**PLANNING DIVISION REPORT
DEPARTMENT OF PLANNING AND COMMUNITY
AND ECONOMIC DEVELOPMENT
March 10, 2008**

RE: I.D. # 09435, Conditional Use Application – Crossroads Drive

Subject: 2702 Crossroads Dr.

REPORT OF: URBAN DESIGN COMMISSION	PRESENTED: January 30, 2008
TITLE: 2702 Crossroads Drive – Hotel Development/Planned Commercial Site. 17 th Ald. Dist. (07906)	REFERRED: REREFERRED: REPORTED BACK:
AUTHOR: Alan J. Martin, Secretary	ADOPTED: POF:
DATED: January 30, 2008	ID NUMBER:

PERMANENT LIMITED NON-EXCLUSIVE
ACCESS EASEMENT AREA

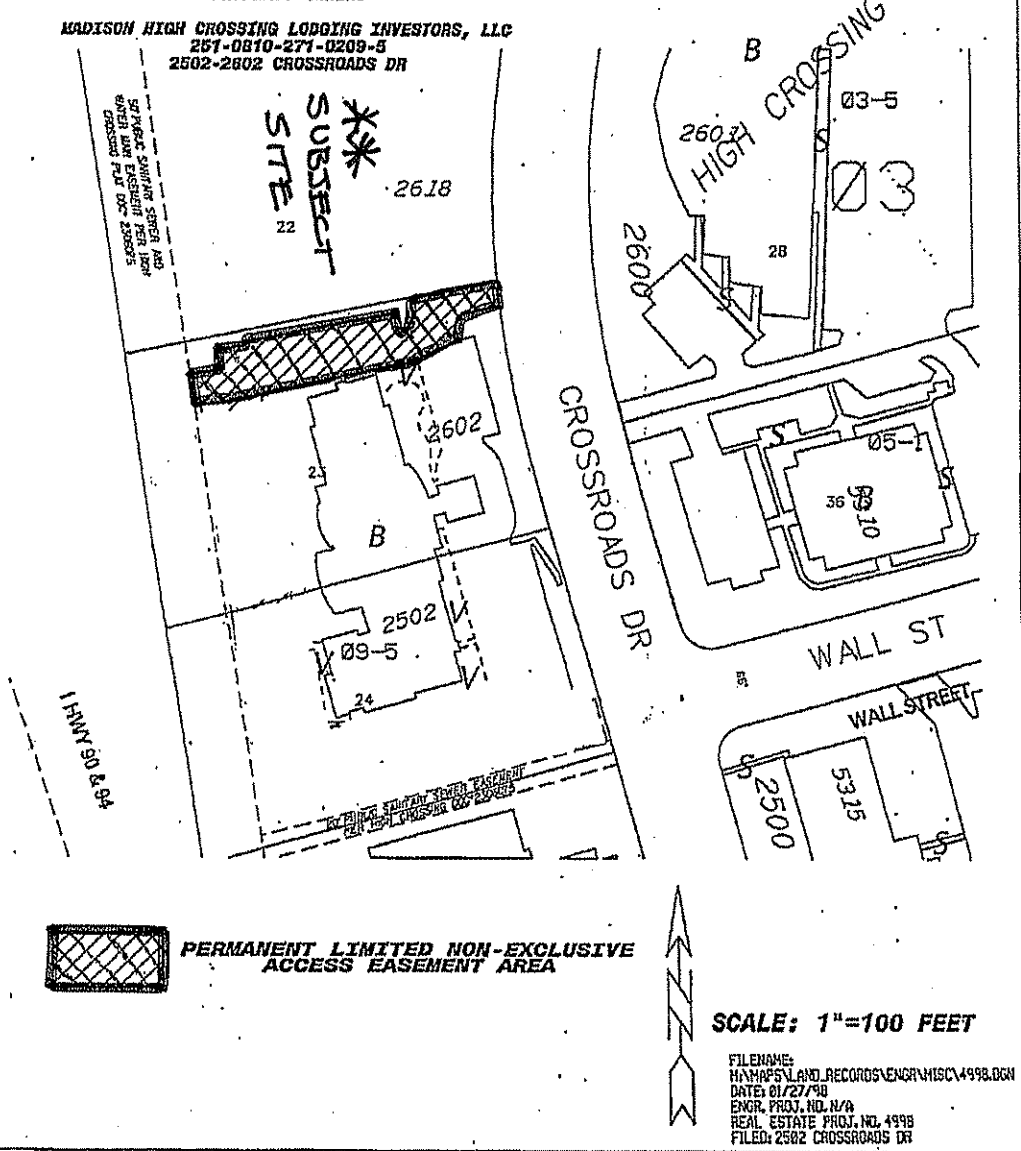
1. A Public Access Easement was granted to the City of Madison from the adjacent property on January 10, 2008 per Document No. 4387787. This public access shall be preserved or relocated, with approval of the City Engineer, at no cost to the City. If the applicant prefers relocation, the new easement shall be executed, recorded and conveyed to the City of Madison prior to issuance of building permits.
